Service Bulletin

- SUBJECT: Service Update for Inventory Vehicles Only Fuse Block Retention Expires February 28, 2016
- MODELS: 2015 Chevrolet Silverado HD 2015 GMC Sierra HD Equipped With 220 Amp Generator (KW5)

Part Being Requested: SERVICE UPDATE BULLETIN 14034 - WPC744

3709055

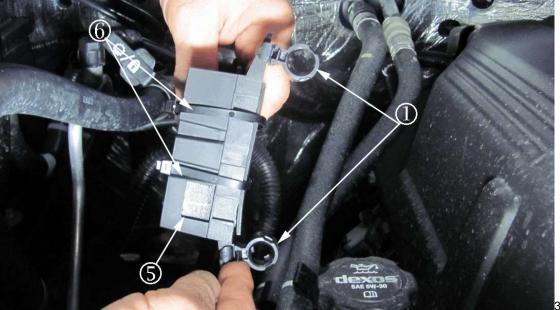
- 1. Open the hood and locate the fuse block housing assembly. The fuse block housing assembly (7) is located on the right (passenger) side shock tower (8) in the engine compartment.
- 2. Determine if the fuse block housing assembly rework has been performed.

• A fuse block housing assembly that has NOT been reworked will have two brown clips (1) that secure the fuse block housing assembly to the shock tower studs. The fuse block housing cover will also NOT have a black polyolefin side window shield (5) or a black polyolefin bottom shield that is secured to the fuse block housing assembly with two black tie straps. If the fuse block housing assembly rework has NOT been performed, perform the rework procedure in this bulletin. Proceed to step 3.

3709042

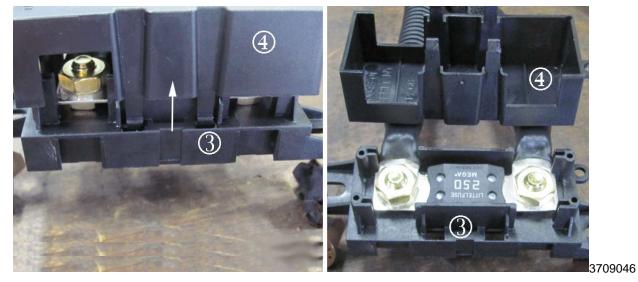
Note: Review the current orientation of the brown clips (1) on the fuse block. Ensure the black clips are installed in the same orientation as the brown clips were installed.

- 4. Remove the brown clips (1) from the fuse block using wire cutters or similar tool.
- 5. Discard the brown clips.
- 6. Install the black clips onto the fuse block.

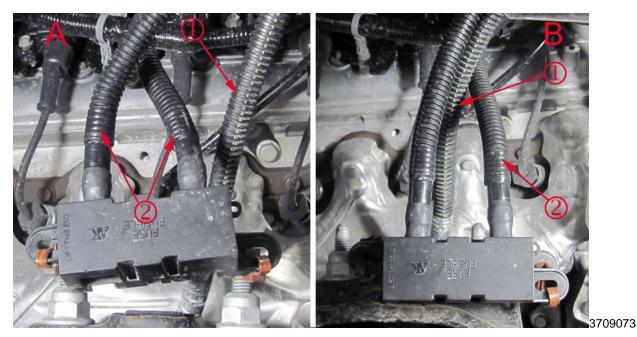
7. Remove the fuse block housing assembly cover (4) from the base of the fuse block (3). The cover (4) is held secure by four small cleats.

- 8. Determine if the cable routing is correct. The starter cable (1) routes forward of the other two fuse-center cables (2).
 - If the cable routing is correct, proceed to step 9. Refer to the 'A' portion of the photograph for the correct routing of the cables. The starter cable (1) is forward of the two fuse center cables.
 - If the cable routing is NOT correct, unfasten the fuse center cable (2) that is to the right of starter cable (1). Refer to the 'B' portion of the photograph to view the incorrect routing of the cables. The starter cable (1) is routed in between the two fuse center cables. Reroute the right fuse center cable (2) to ensure the starter cable (1) is routed forward of the two center fuse cables. Next, re-install the fuse center cable (2) to the fuse block. Proceed to step 9 after correcting the cable routing.

3709038

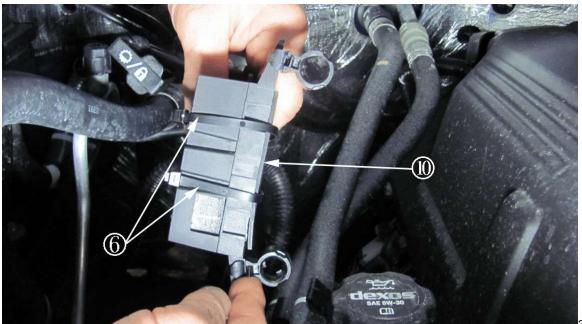
- 9. Insert a 23 x 26 mm (0.90 in x 1 in) black polyolefin shield inside the fuse block cover in the fuse block cover window area (5) as shown in the 'A' portion of the photograph.
- 10. Snap the fuse cover over the fuse block base as shown in the 'B' portion of the photograph. This will wedge the black polyolefin shield into place and close off the side fuse cover window (5).

3709051

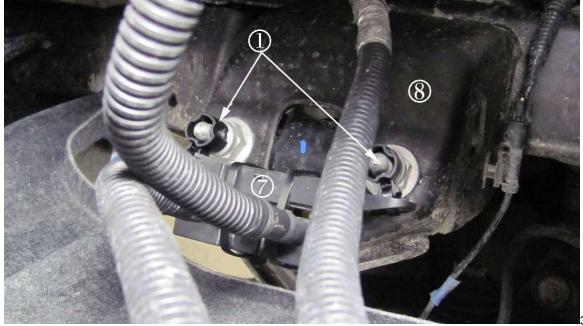
- 11. Place a 38 x 100 mm (1.5 in x 3.9 in) black polyolefin shield (10) over the bottom of the fuse block.
- 12. Secure the black polyolefin shield (10) to the bottom side of the fuse block using the two tie straps (6).
- 13. Pull the tie straps (6) tightly to secure the shield to the bottom side of the fuse block.
- 14. Cut the excess tail from the tie straps.
